REVIEW OF EMERGENCY RESPONSE
CONSIDERATIONS FOR THE VALLEY
CENTER ROAD CORRIDOR CONCEPT
PLAN DESIGN OPTIONS

FINAL REPORT

SAN DIEGO COUNTY

SUPPLEMENT TO THE SEPTEMBER 2023 REVIEW OF
EMERGENCY RESPONSE CONSIDERATIONS FOR THE VALLEY
CENTER ROAD CORRIDOR CONCEPT PLAN DESIGN OPTIONS:
ADDRESSING THE DRAFT FINAL CORRIDOR CONCEPT PLAN

Exhibit 5:
Roundabout Turn Template: CalFire Truck with Trailer for Bulldozer
(Dimensions match specifications provided by the County Fire Protection District)

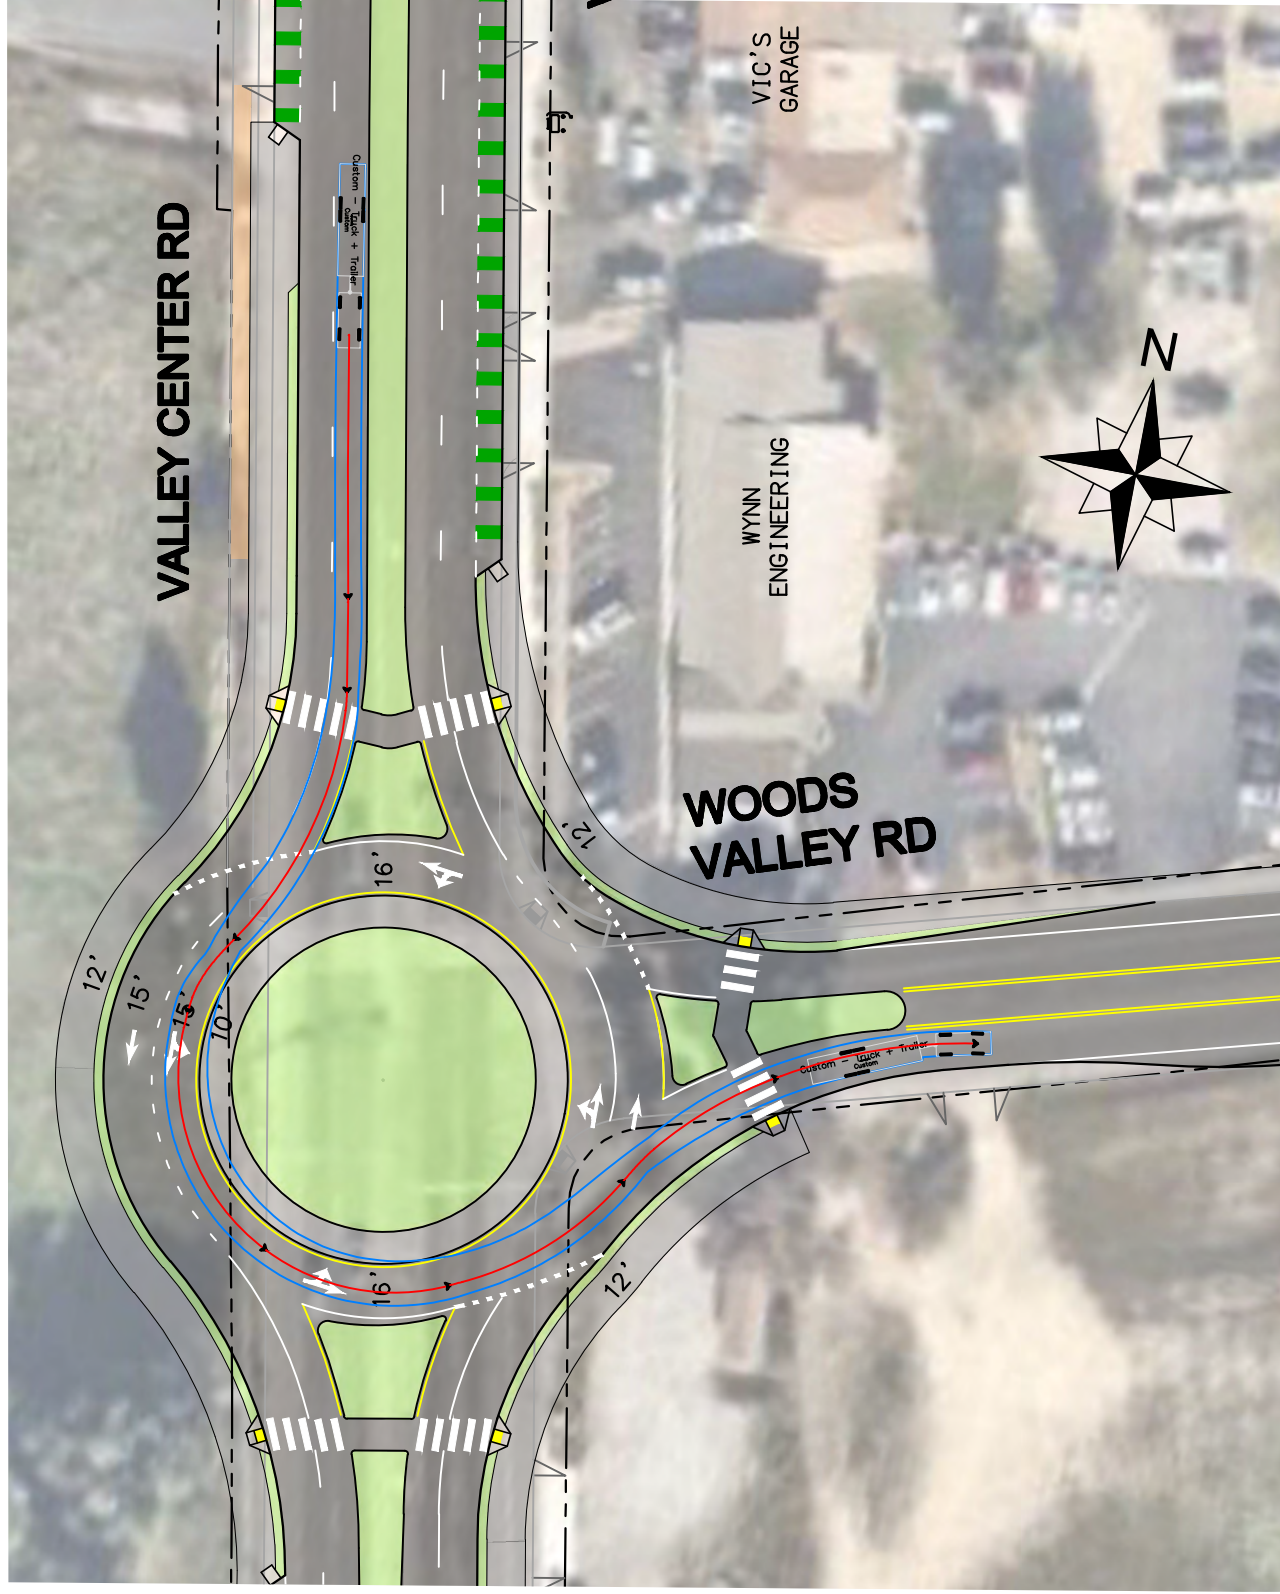
Turn templates have been provided (Exhibits 4, 5, and 6 to this report) to show how large vehicles will be able to navigate the roundabouts, including addressing the dimensions of the largest VCFPD vehicle (aerial ladder truck) and a Cal Fire truck with bulldozer trailer. In reviewing the current literature on roundabouts, Citygate determined the proposed roundabout design to represent best practice for both larger vehicles and higher-volume traffic throughput. Roundabouts may not be as common in the United States as they are abroad, but they are also not rare. Along with our legacy experience with traffic safety design impacts on emergency services, Citygate researched the most recent findings related to roundabouts both in the United States and abroad.

EXHIBIT 10

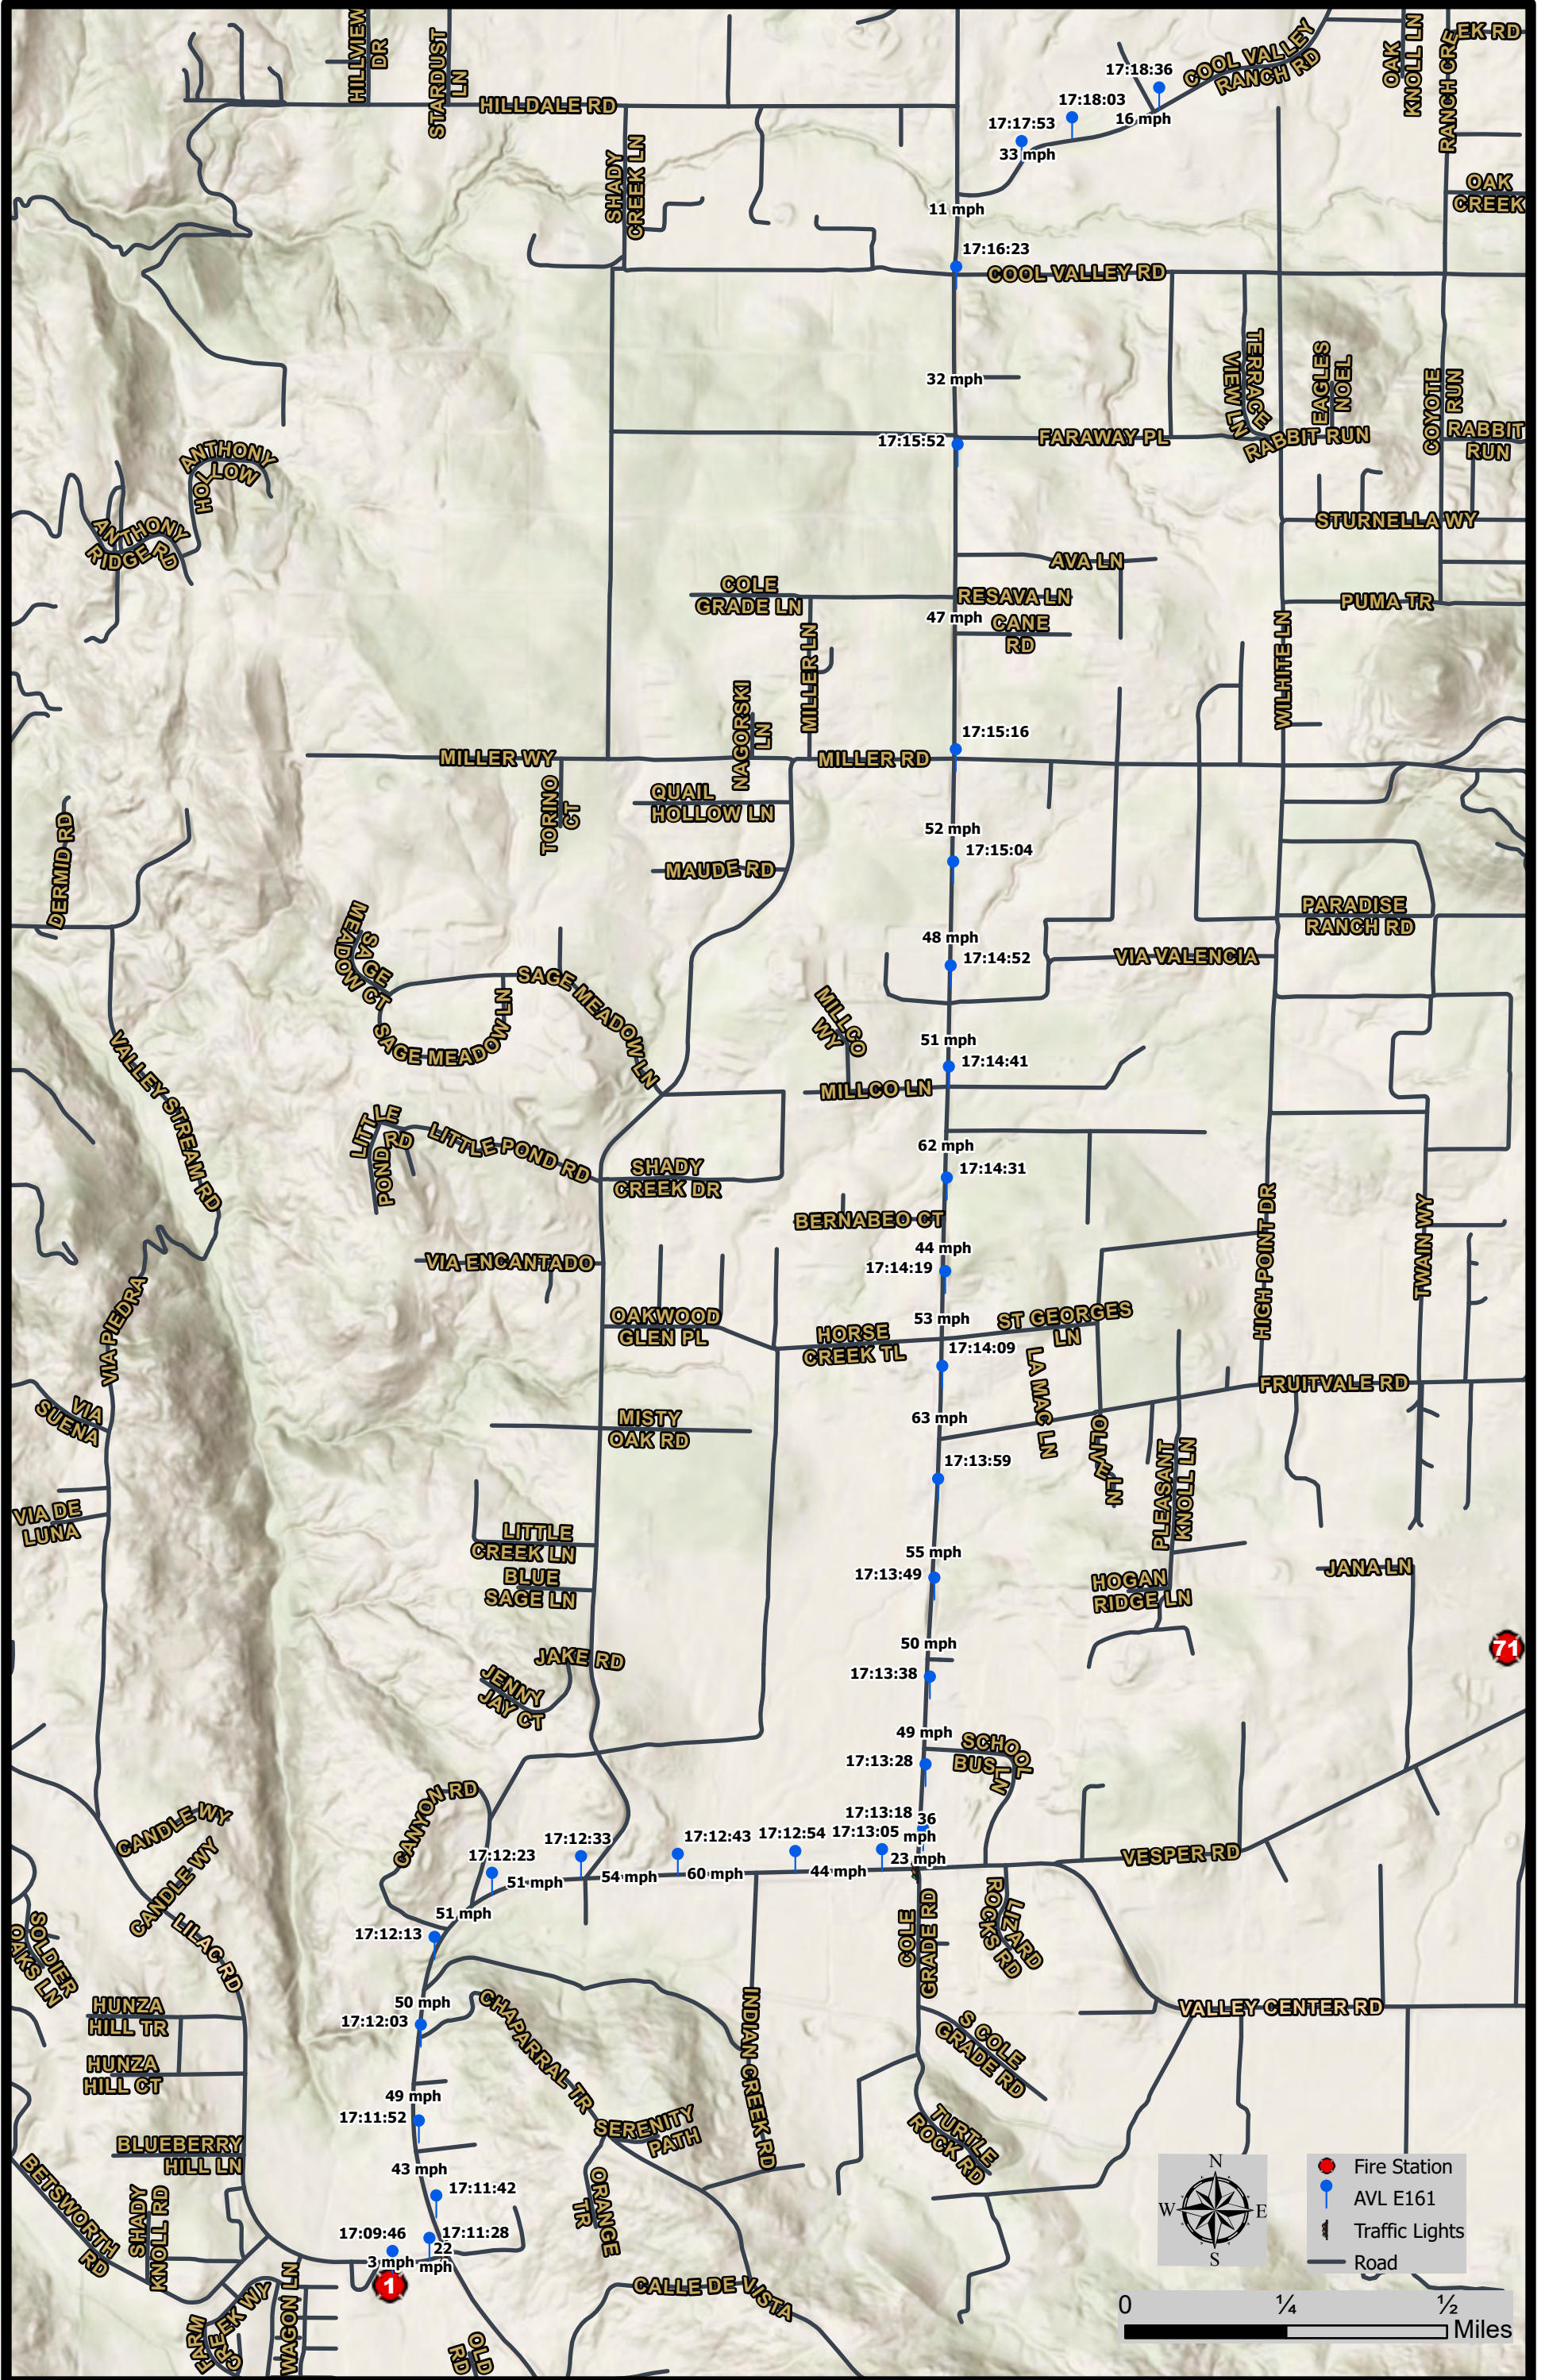
To understand the affect the traffic control devices would have on emergency response time, Citygate first needed to establish a baseline understanding of current fire unit travel times. The measures were from Fire Station 1 on Lilac Road to both the north and south ends of the CCP's geographic scope from Cole Grade Road to Woods Valley Road. Citygate, the Valley Center Fire Protection District, and their dispatch center identified incidents where a fire unit responded from Station 1 to an emergency occurring past the end of the CCP project's limits. The fire units have a GPS transponder, so the dispatch center knows to send the closest unit. This technology can also measure response travel time at intervals along a given route. Citygate / Fire District-provided Exhibits 10 and 11 are the result of these incident measures.

- ◆ The northern fire unit response travel time inside the CCP's geographic scope—from Fire Station 1 to the fire unit GPS waypoint just onto Cole Grade Road (approximately 1.5 miles)—was 3:32 minutes/seconds.
- ◆ The southern fire unit response travel time inside the CCP's geographic scope—from Fire Station 1 to the fire unit GPS waypoint just off Valley Center Road on Woods Valley Road (approximately 1.4 miles)—was 2:27 minutes/seconds.

Exhibit S-1 - Draft Final Valley Center Road Corridor Concept Plan

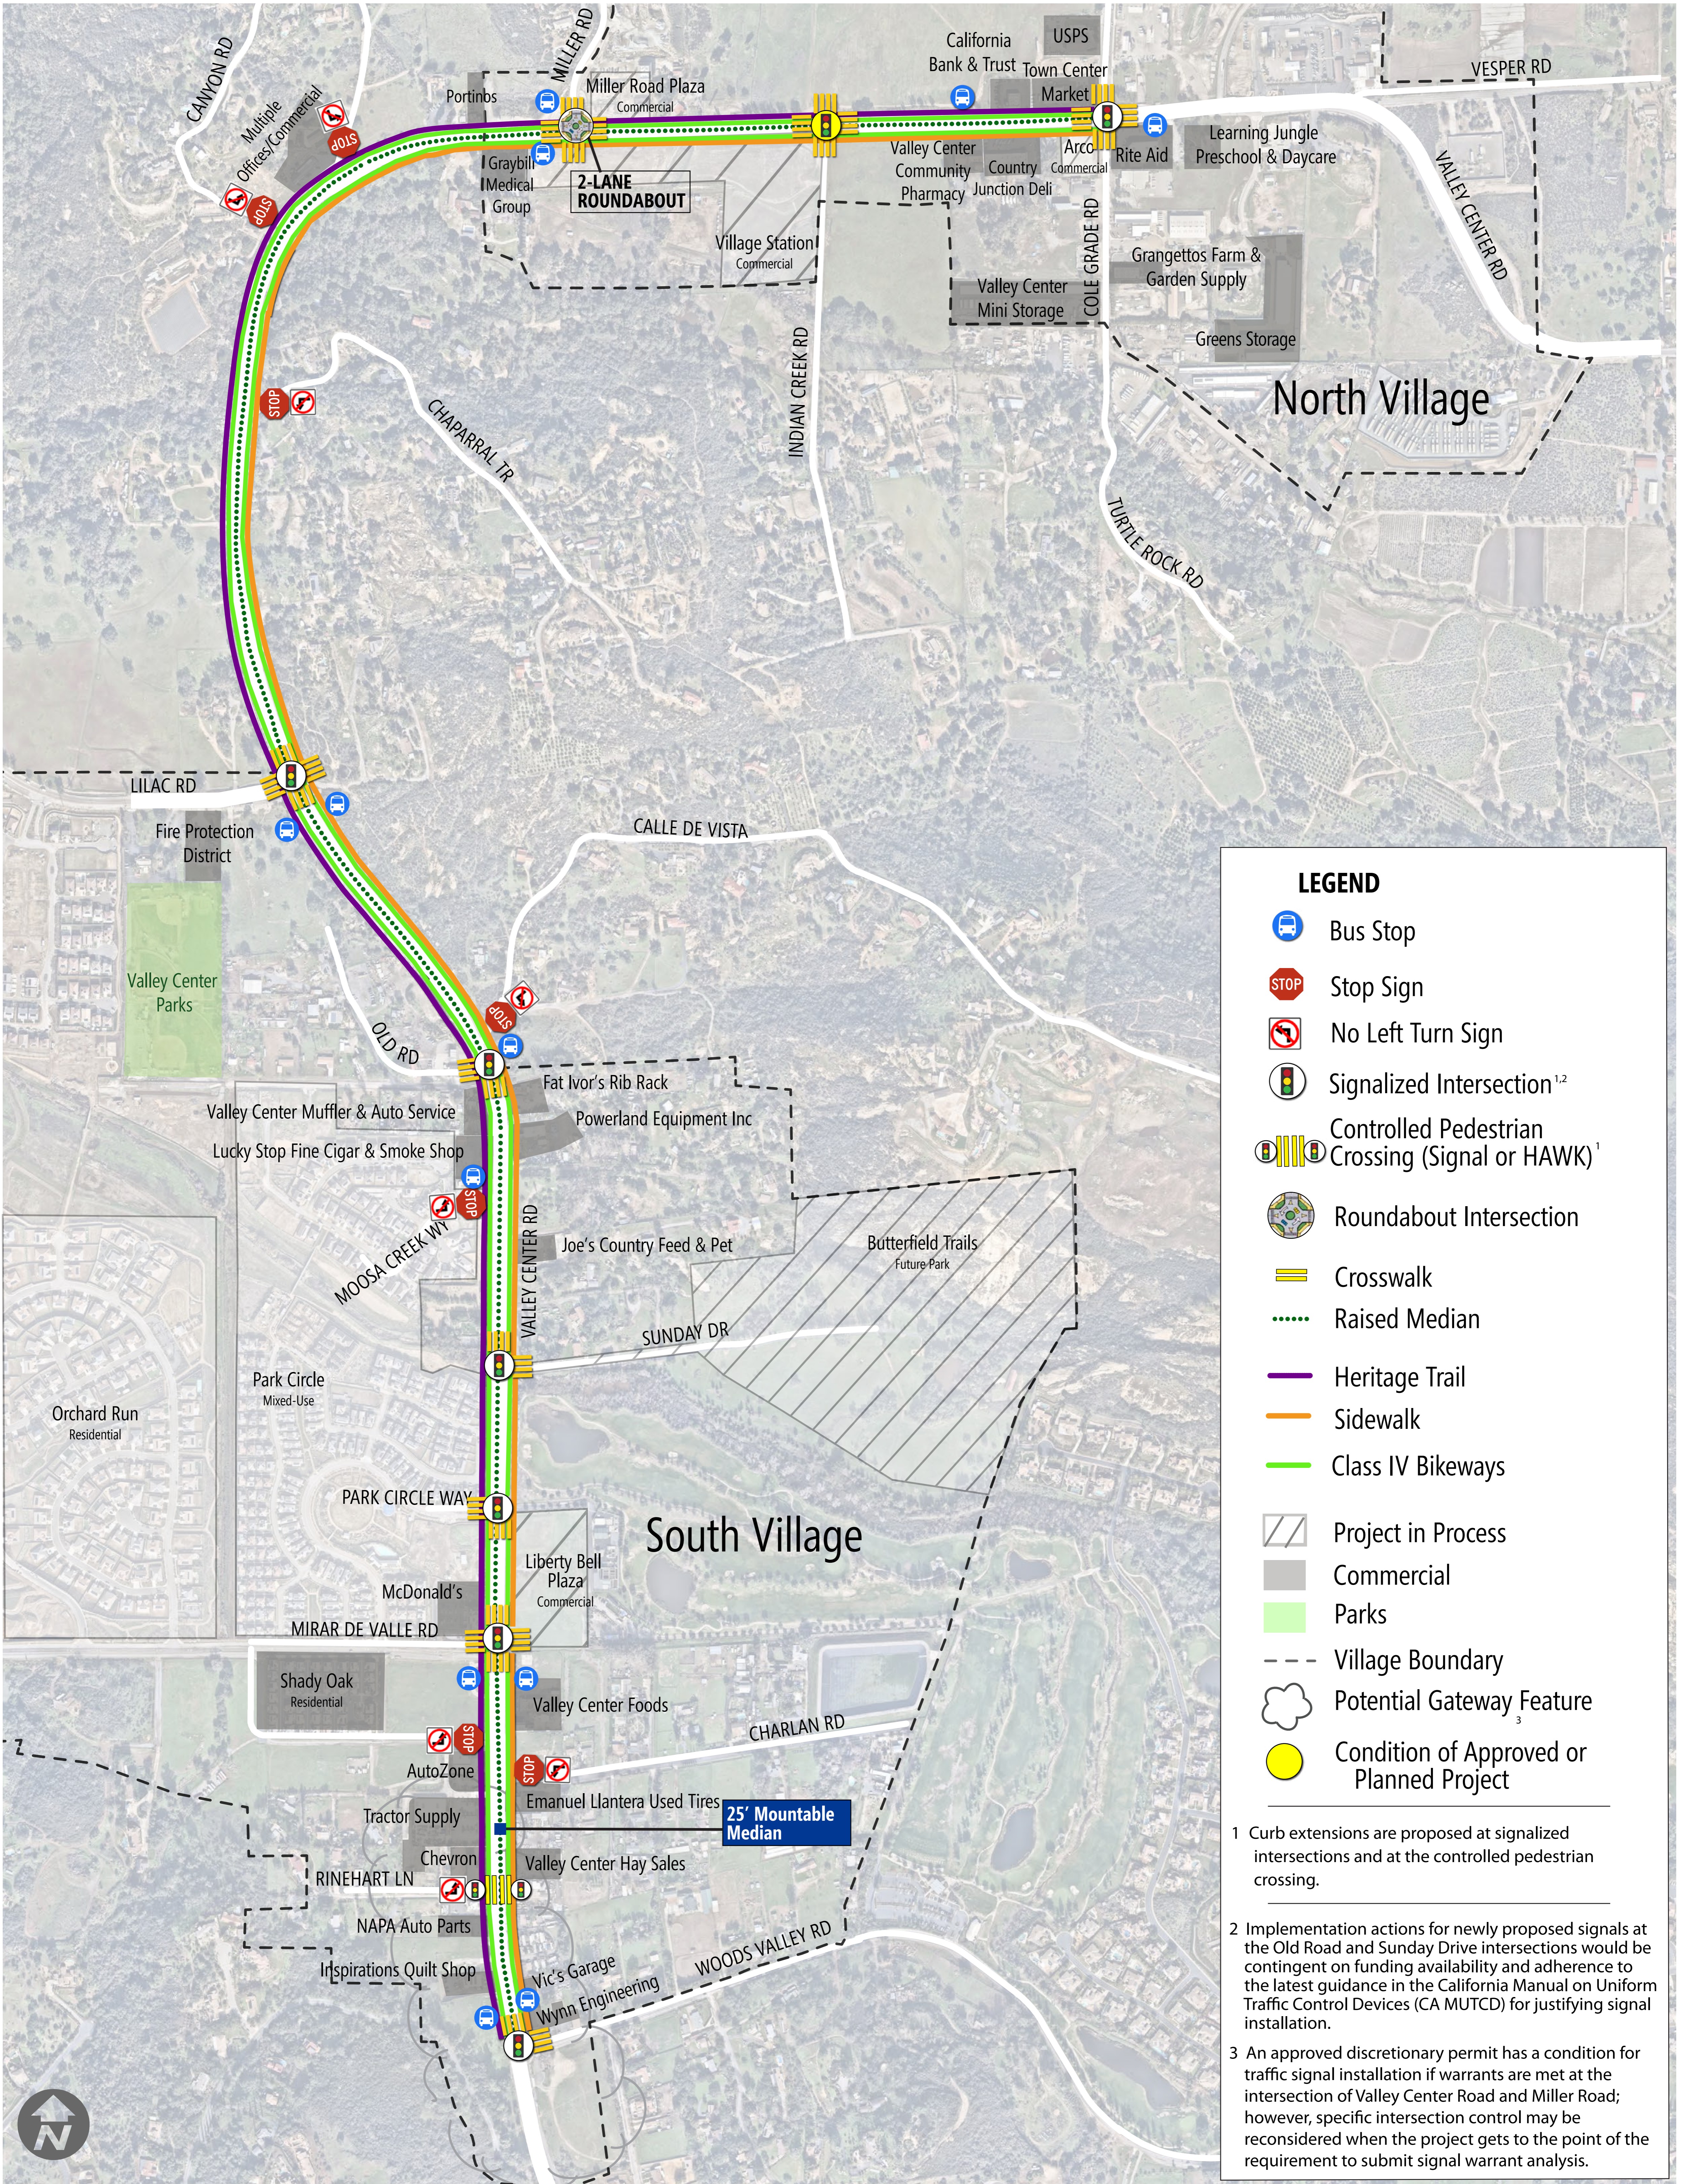
Following several outreach meetings for consideration of the three CCP options addressed in Citygate’s 2023 report, the Valley Center Community Planning Group (CPG) voted on February 12, 2024, to recommend new CCP Option A with one revision: to remove the Woods Valley Road intersection roundabout included in that option. All other components of Option A would apply to the Draft Final CCP per this CPG recommendation, including the proposed roundabout at the Miller Road intersection. This CPG recommendation is now the Draft Final CCP and is addressed in this supplement to Citygate’s 2023 Report, which addressed previous CCP Options A, B, and C. Plan sheets for this Draft Final CCP can be found in Exhibit S-1.

- In the full corridor one-page plan sheet attached as Exhibit S-1, these newly proposed signals and existing signals are depicted with white circles surrounding the signal symbol. The signals with yellow circles are conditions of private development projects and are not considered part of the improvements planned with the Valley Center Road CCP.

In Citygate's experience, the exchange of one roundabout for a signal-controlled intersection is not a major enough design change to significantly change the summary findings in our initial 2023 review of the corridor design elements as to impacts on public safety access. Citygate has revisited and then compared in depth the findings of our September 2023 report that related to evaluation of the 2023 CCP options for emergency response and evacuation consideration. For clarity, we list below all of our 2023 findings and, where needed, address changes given the 2024 Draft Final CCP.
